B I D A D D E N D U M 0 5

The items set forth herein, whether of omission, addition, substitution, or clarification are to be included in and form a part of the construction documents for the project listed above.

ORANGE-ULSTER BOCES
AXELROD - MAIN
BUILDING
ADDITIONS +
ALTERATIONS
53 GIBSON ROAD
GOSHEN, NY 10924

ELECTRICAL:
FIRST FLOOR
LIGHTING PLAN
PART B

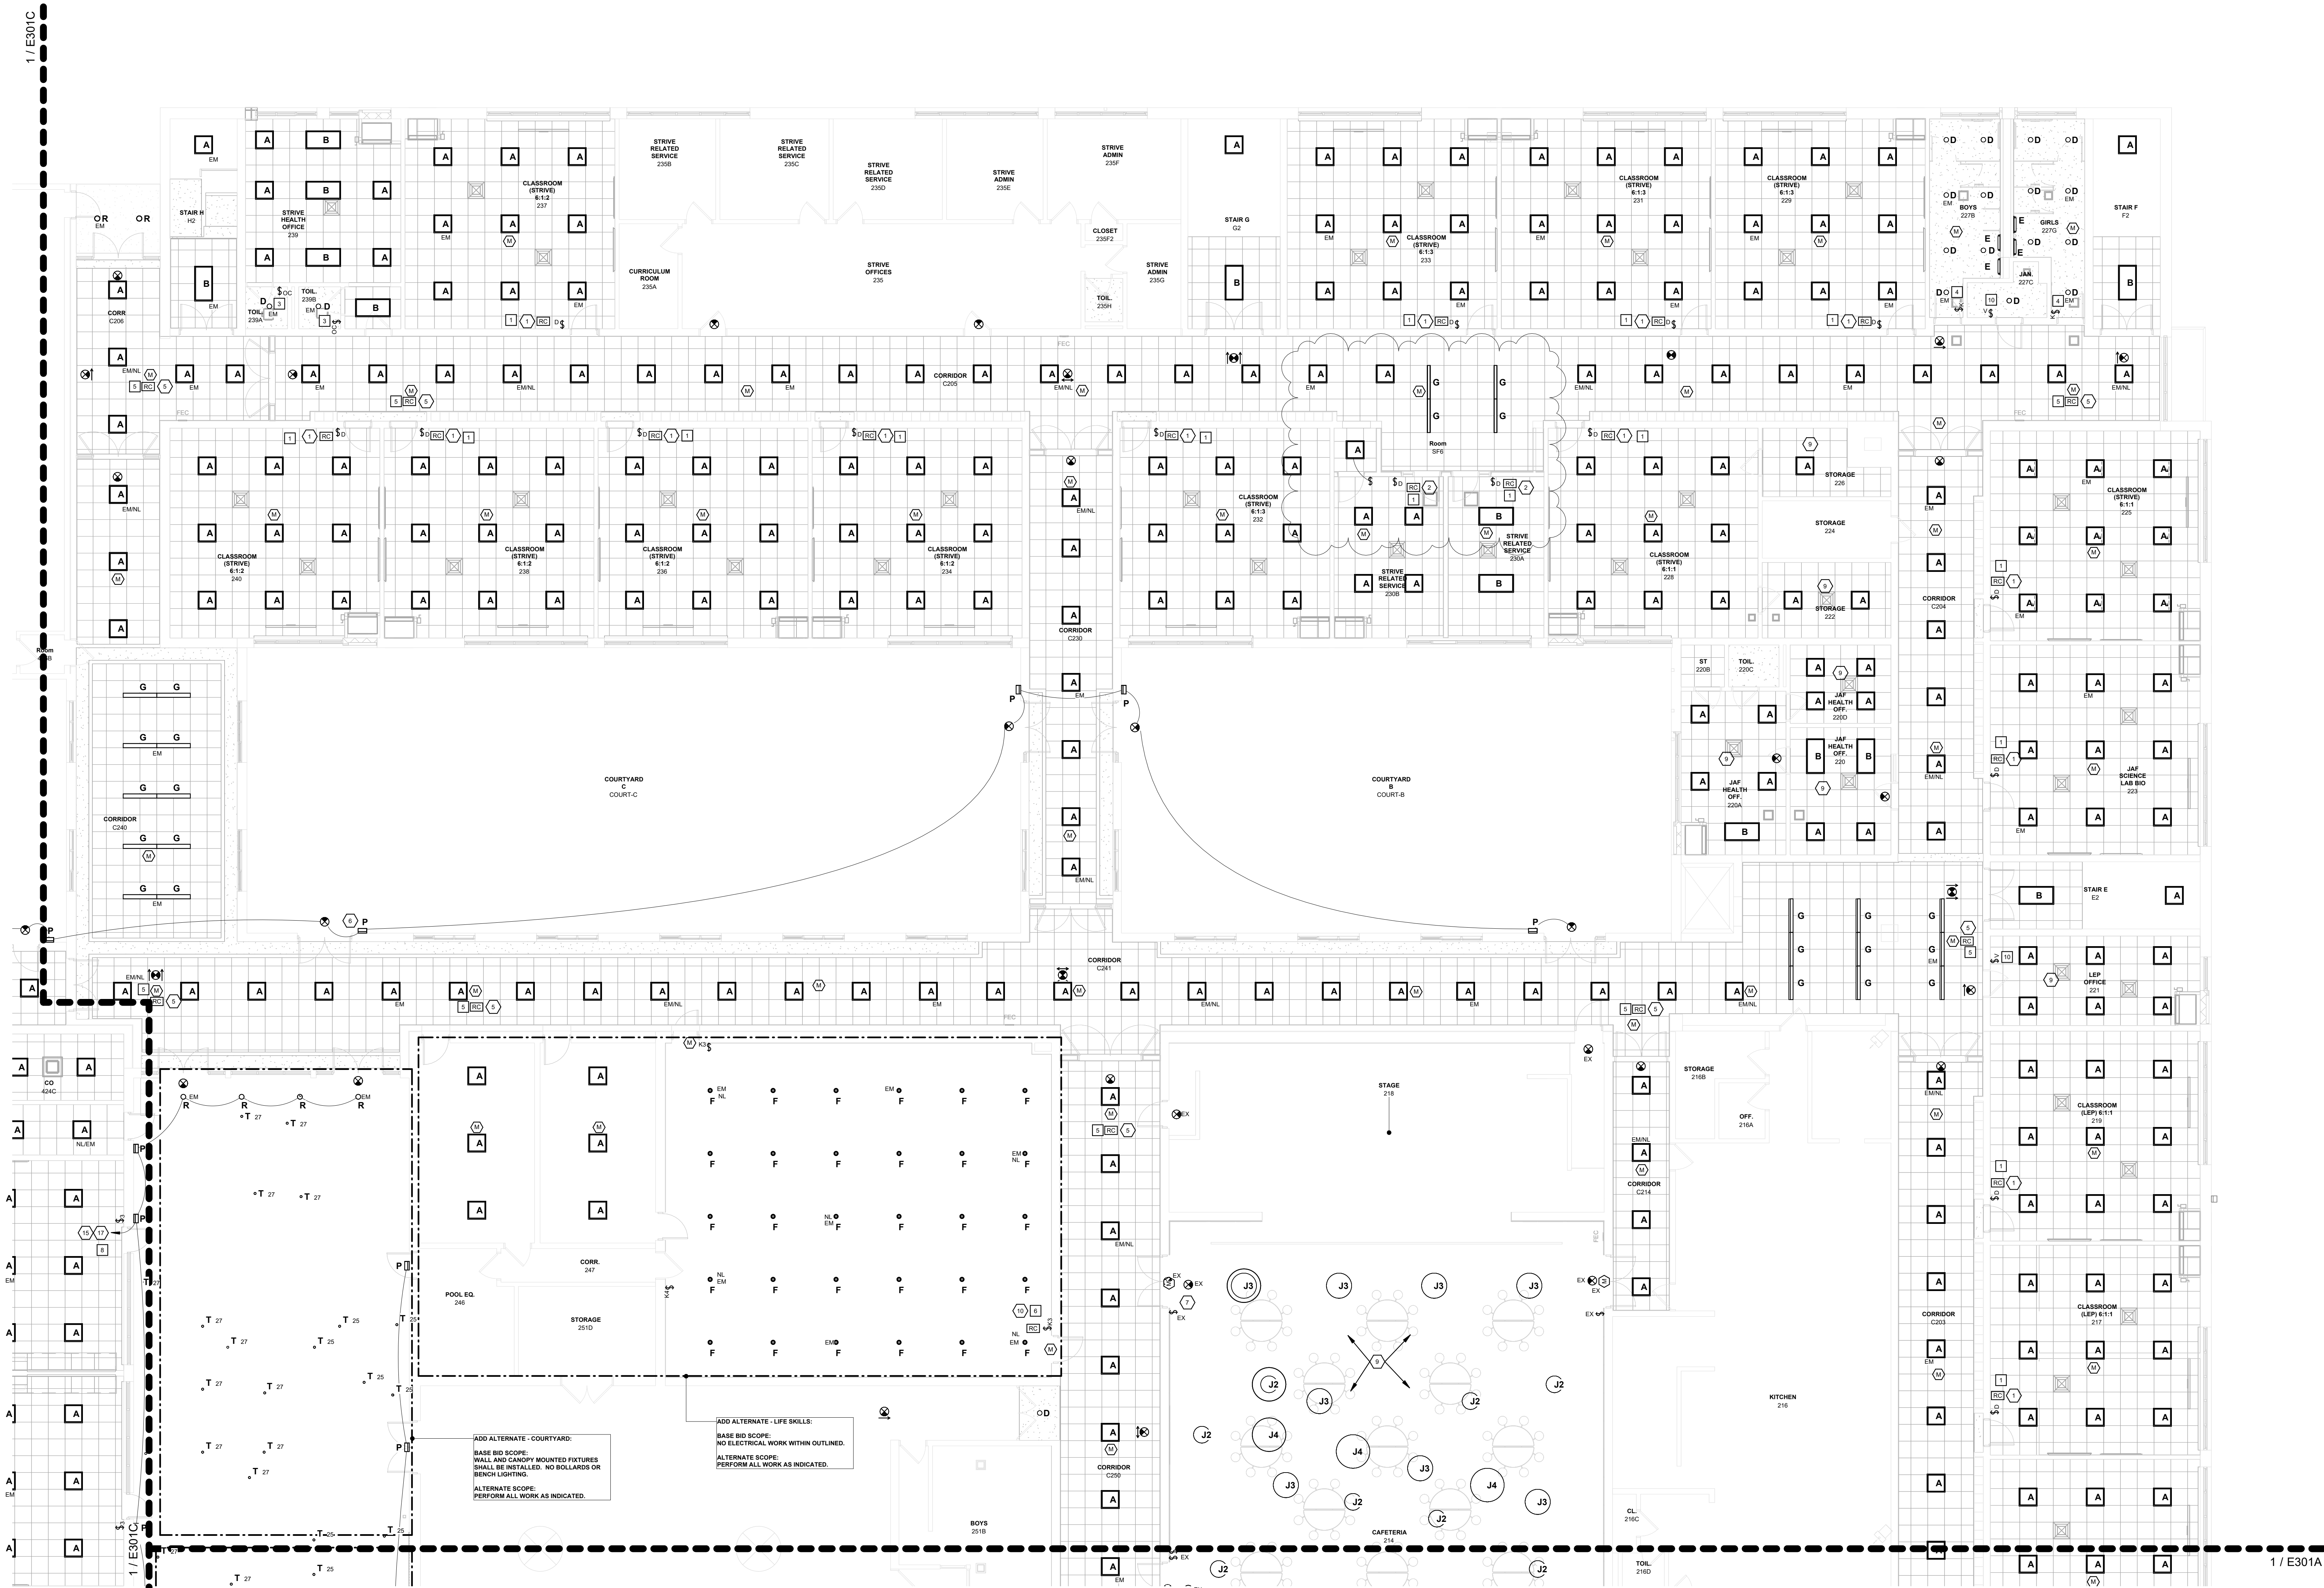
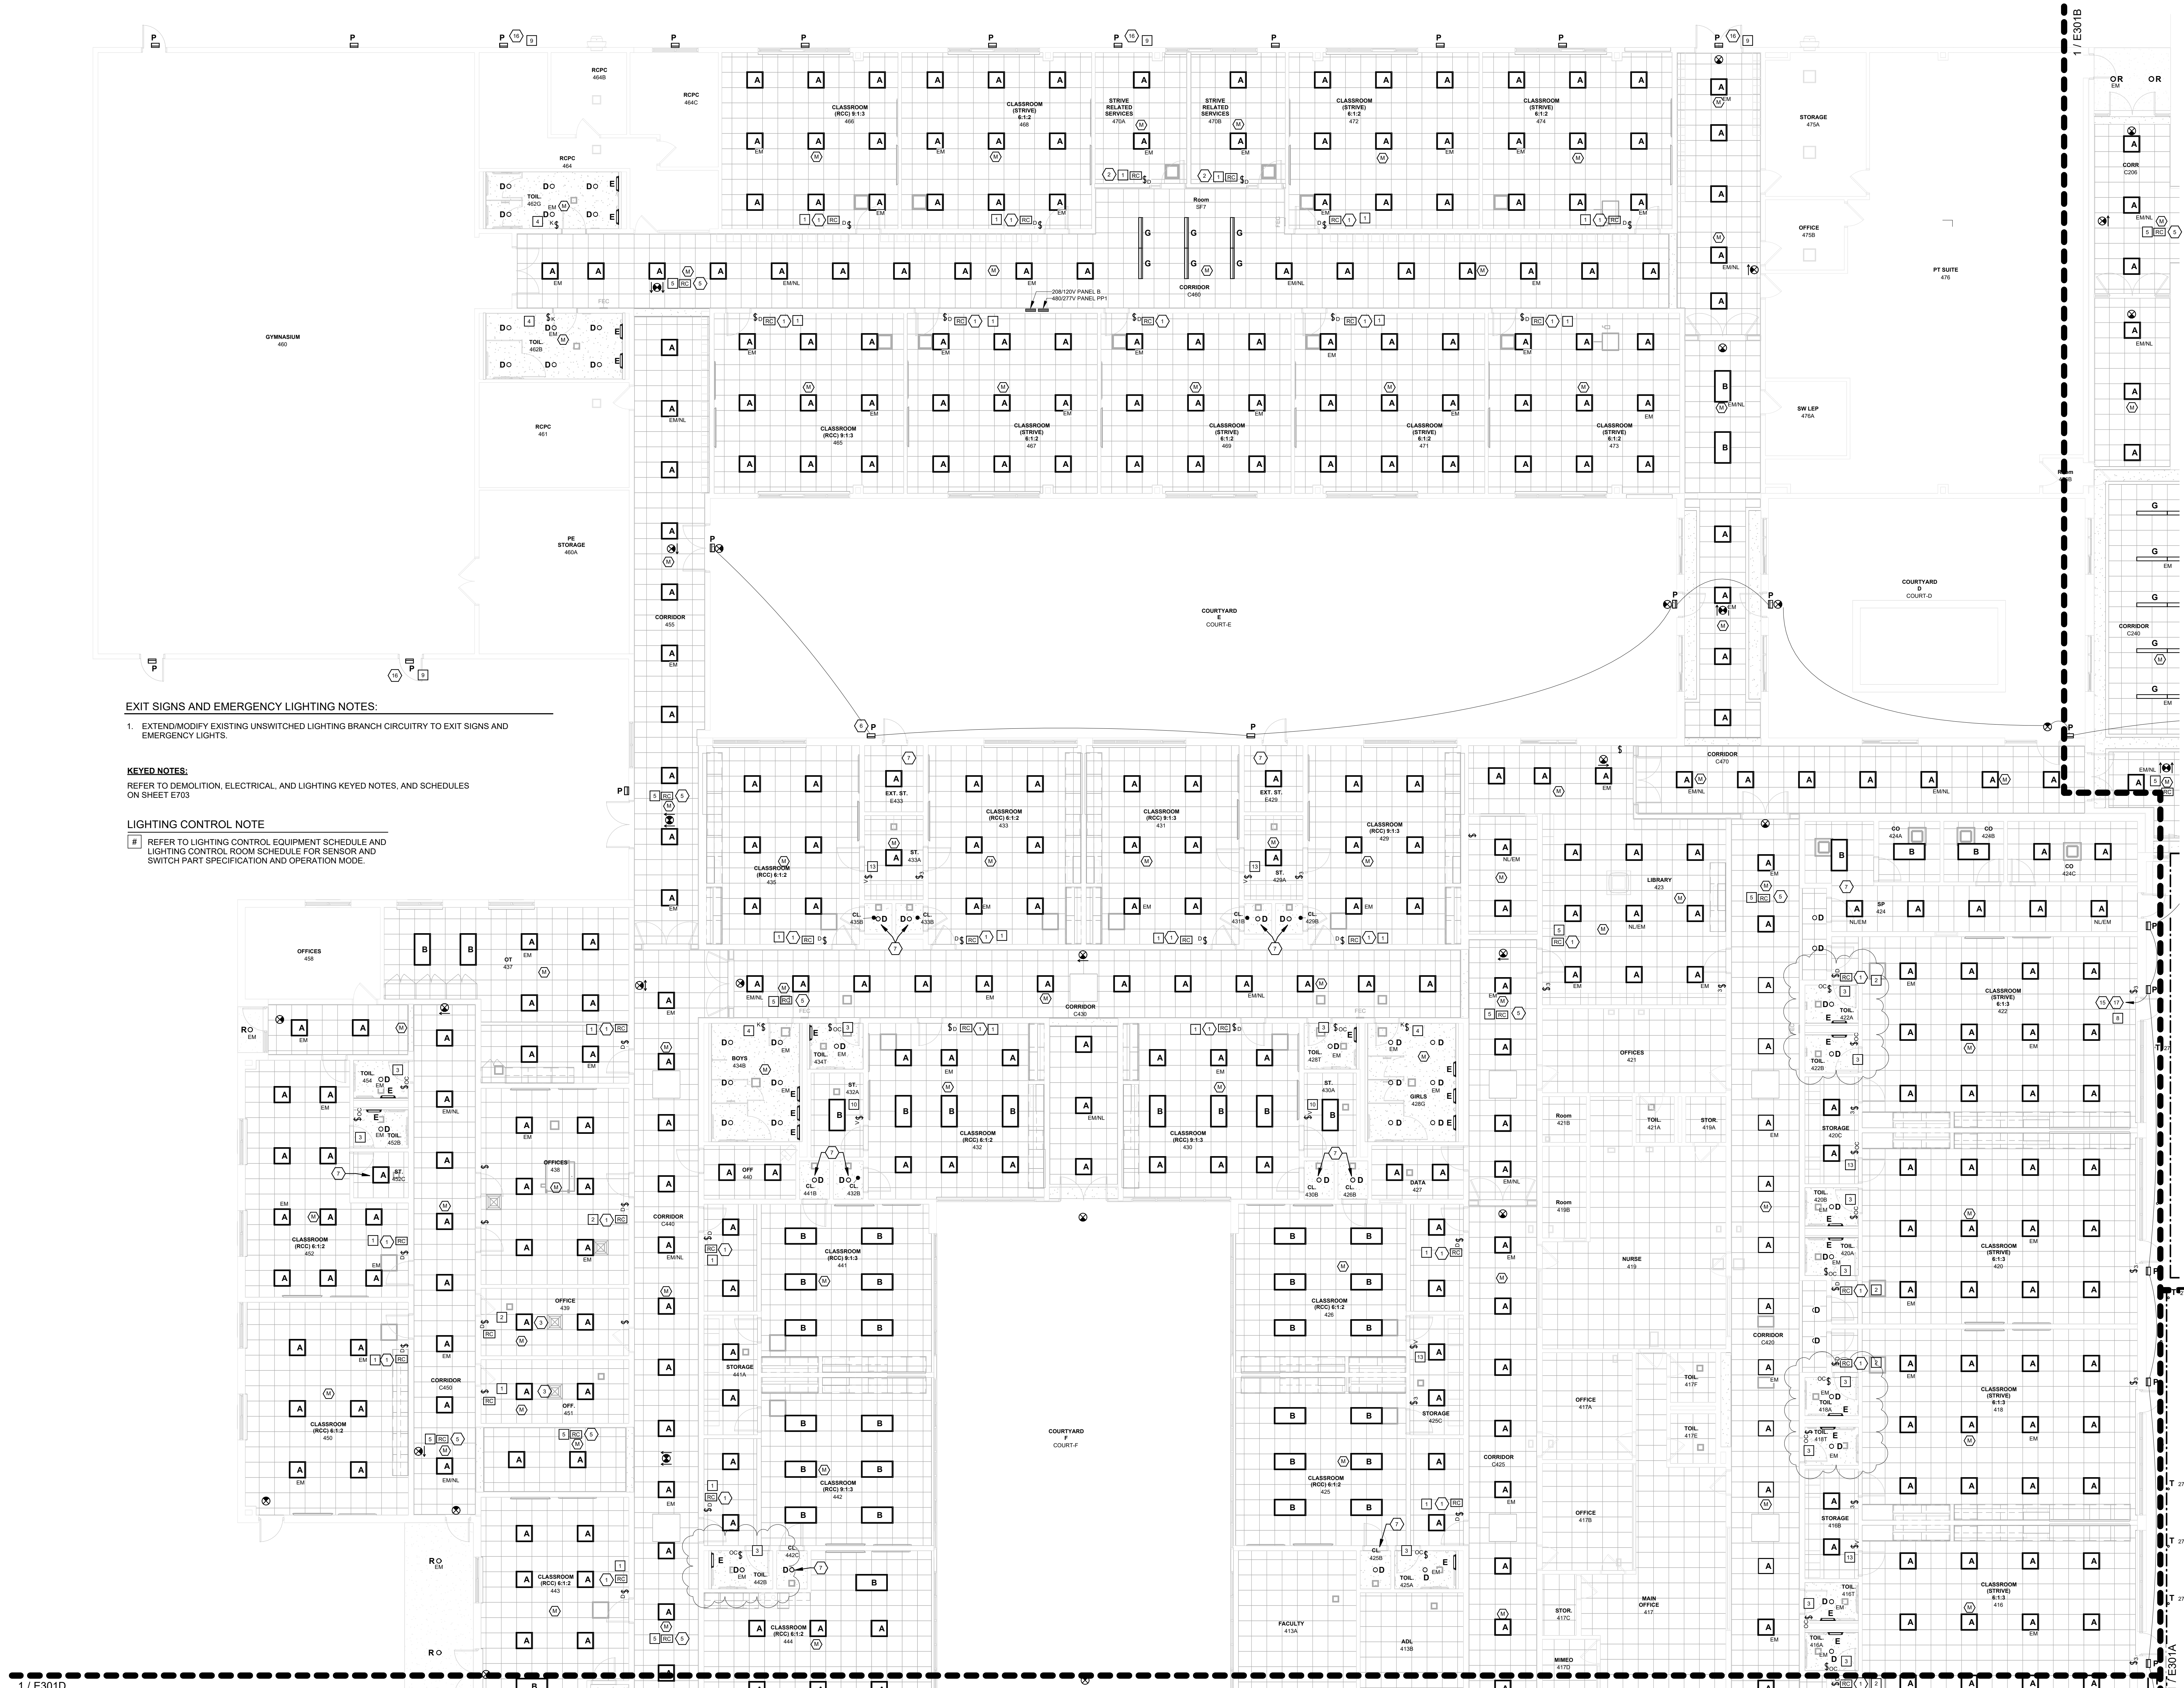
- 7.8 RFI Question – There are unlabeled light fixtures throughout Drawings E300B, E301A, E301B, E301C, E301D, E302A, E302B. Please advise.
RFI Response – See attached revised electrical drawings with light fixtures labeled.
